# STAFF REPORT ACTION REQUIRED

Request for approval of variances from the former City of Scarborough Sign By-law No. 22980, as amended, for one ground sign and five facial wall signs at 1399 Kennedy Road.

Date:	January 2, 2007		
To:	Chair and Members, Scarborough Community Council		
From:	Bruce Ashton, Director of Building and Deputy Chief Building Official		
Wards:	Scarborough Centre – Ward 37		
Reference Number:	2007SC002

# ATTACHMENT 3 - GROUND SIGN

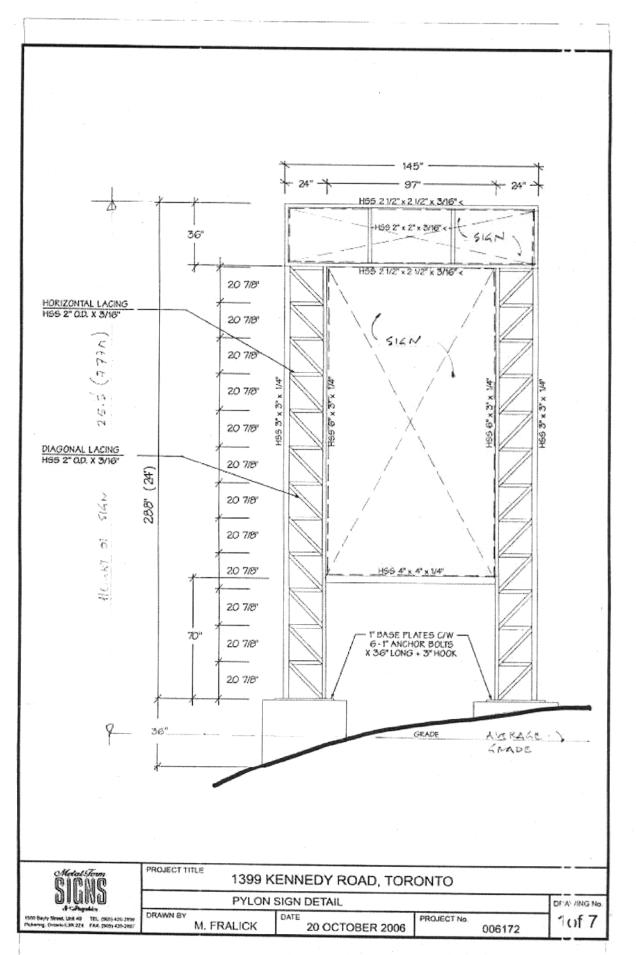
The height of the ground sign is 1.57% over what is permitted, but due to sloping ground at the base of the sign, staff considers this variance minor. However, the aggregate area of the ground sign for this property is 27.18% over what is permitted by the Sign By-law. This variance is not minor and the sign does not meet the intent of the by-law. Staff recommends refusal of the requested variances for the ground sign.

Sign By-law Section & Requirements	Applicant's Proposal	Required Variance
2.3.5(4) (d)(v)		
The maximum area per sign face, with respect to identification or business or	To erect a premises ground sign with a sign area of 14.60 m <sup>2</sup>	To allow the erection of a premises ground sign with a sign area of 14.60 m <sup>2</sup>
promotional advertising sign faces only, shall not exceed:		
for Group 4 Use premises the	Permitted sign area, based on the	The proposed sign area is
greater of 7m <sup>2</sup> or 1m <sup>2</sup> for	length of the street frontage, is	3.12m <sup>2</sup> , or 27.18% greater
each 15m of street frontage	11.48 m <sup>2</sup>	than the permitted sign area

2.3.5(5) (a) (ii)	To erect a premises ground sign	To allow the erection of a
The maximum permitted	with an overall height of 7.77m	premises ground sign with
height of a sign face above		an overall height of 7.77m
grade shall not exceed	* · ·	
1m for each 1.5m <sup>2</sup> of		
permitted sign face area, for	Permitted overall sign height,	The proposed sign height is
permitted areas in excess of	based on the permitted sign area,	0.12m, or 1.57% greater than
10m <sup>2</sup>	is 7.65m	the permitted height

- (1) the request for variances for the ground sign to be denied for the reasons outlined in this report; and
- (2) the request for variances for the five facial wall signs be approved for the reasons outline in this report.

ATTACHMENT 4 - TOWER SIGNS

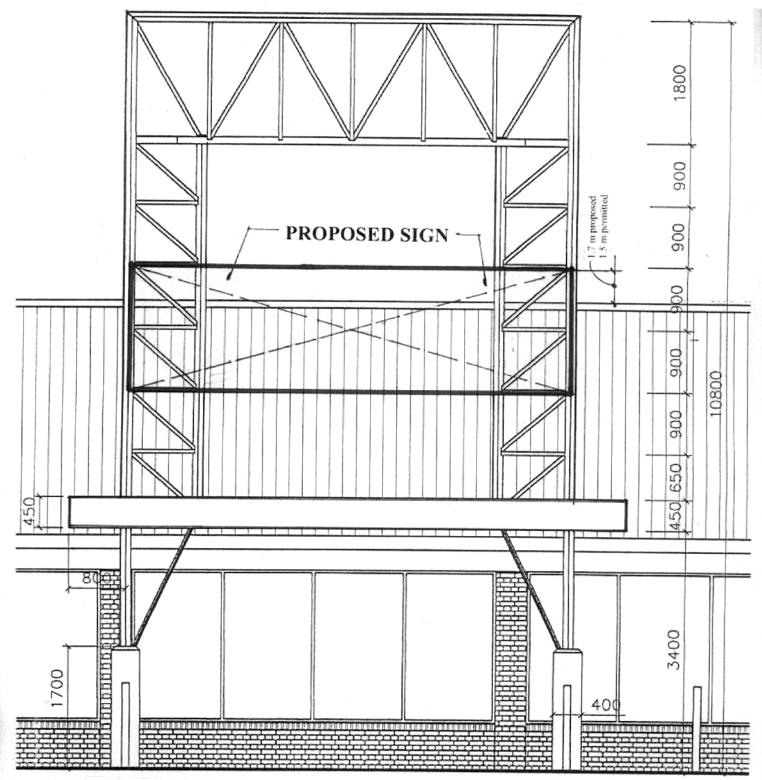
The facial wall signs project 13.33% higher than what is permitted in the Sign By-law. Due to the sloping ground surrounding the building, staff considers this variance minor and recommends approval of the requested sign variance for the five facial wall signs.

The five steel tower structures are spread unequally along the most westerly façade of the building. The towers are 6.2m wide by 2m deep by 10.8m high. The structures extend 3.12m above the parapet wall of the existing building and are located 1.3m westerly from the face of the existing wall. A sign box is proposed to be erected on each tower facing Kennedy Road. These signs are functionally considered as facial wall signs.

2.3.9(5)(a) No sign shall be erected on a roof which would have its sign face project above the roof deck a distance greater than the lesser of, for facial roof signs, 25 percent and for projecting roof signs, 50 percent of the height, measured directly below the sign, of the roof deck above grade or of the average height of the first storey. If a	To allow facial signs to project above the roof deck a distance of 1.7m above the parapet wall.	To allow the erection of facial wall signs projecting above the roof deck a distance of 1.7m above the parapet wall.
parapet wall extends above the roof deck, the aforesaid distances may be measured from the top of the parapet wall.	Permitted projection is 1.5m	The proposed projection would be 0.2m, or 13.33% higher than what is permitted in the Sign Bylaw.
